# ADDENDUM TO THE CONTRACT

#### Bartlett Regional Hospital Water and Sewer Upgrades Contract No. BE22-185

ADDENDUM NO.: TWO

Item No. 4 SHEET C203, UTILITY PLAN VIEW, "SPECIAL WATER MAIN NOTE" Section, *Replace* with the following:

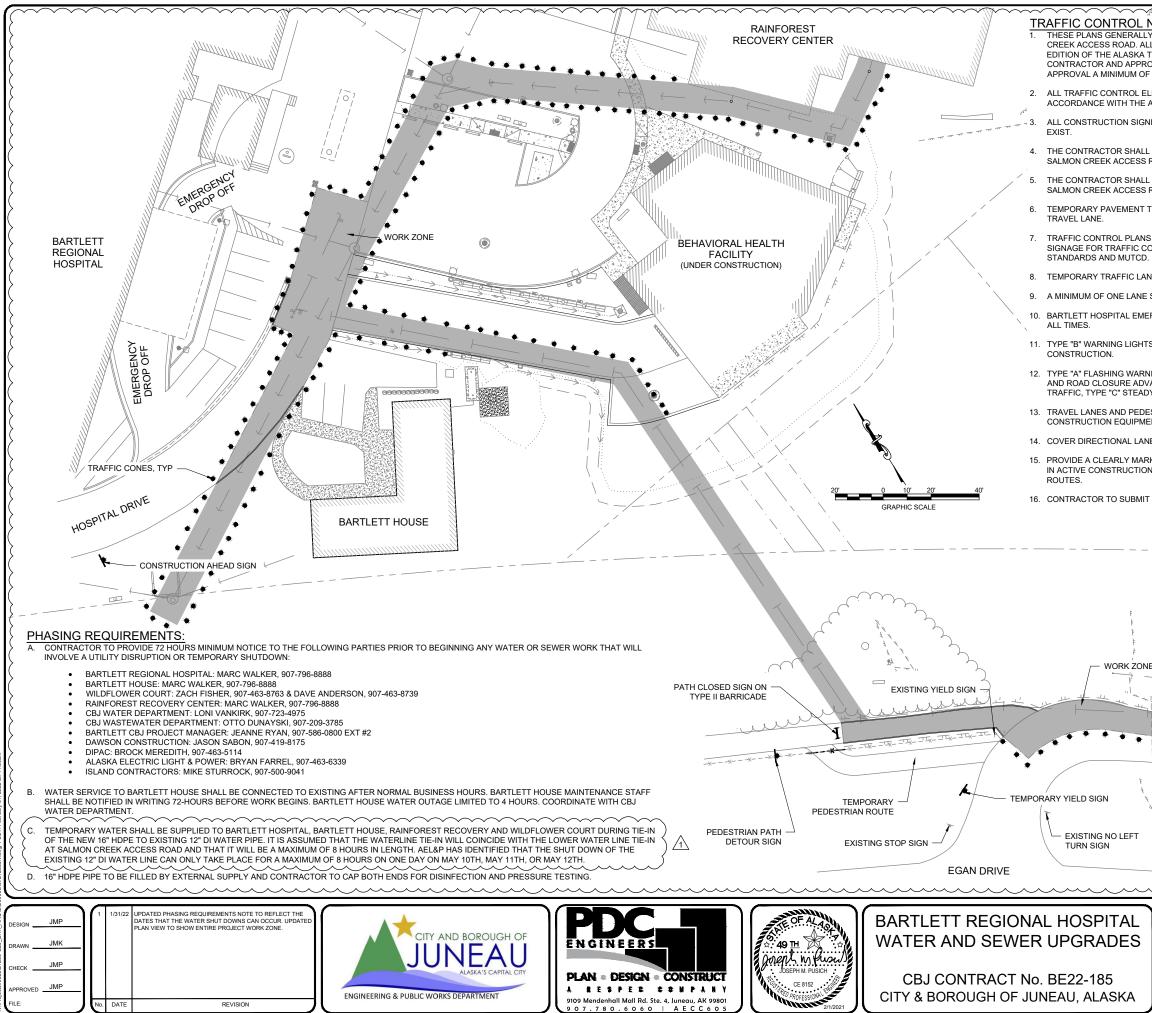
THE EXISTING 12" DUCTILE IRON WATER MAIN IS THE PRIMARY SUPPLY LINE FOR A 2" HDPE WATER SERVICE TO AEL&P. THIS SERVICE ALSO SUPPLIES WATER TO DIPAC. THE MAXIMUM ALLOWABLE SHUTDOWN TIME FOR THE 2" HDPE SERVICE IS 8 HOURS AND CAN ONLY HAPPEN ON ONE DAY ON MAY 10<sup>TH</sup>, MAY 11<sup>TH</sup>, OR MAY 12<sup>TH</sup>. WATER FLOW CAPACITY SHALL BE MAINTAINED IF THE CONTRACTOR PLANS TO INSTALL A TEMPORARY BYPASS LINE. ALL TEMPORARY WATER SYSTEM PLANS AND INTERRUPTIONS SHALL BE REVIEWED AND APPROVED BY LONI VANKIRK (723-4975) WITH THE CBJ WATER UTILITY DEPARTMENT AND BYRAN FARREL (463-6339) WITH AEL&P PRIOR TO IMPLEMENTATION. THE CONTRACTOR SHALL DEMONSTRATE THAT ADEQUATE LABOR-FORCE AND ALL PARTS AND TOOLS WILL BE PROVIDED TO COMPLETE THE WORK WITHIN THE APPROVED SHUT DOWN TIME.
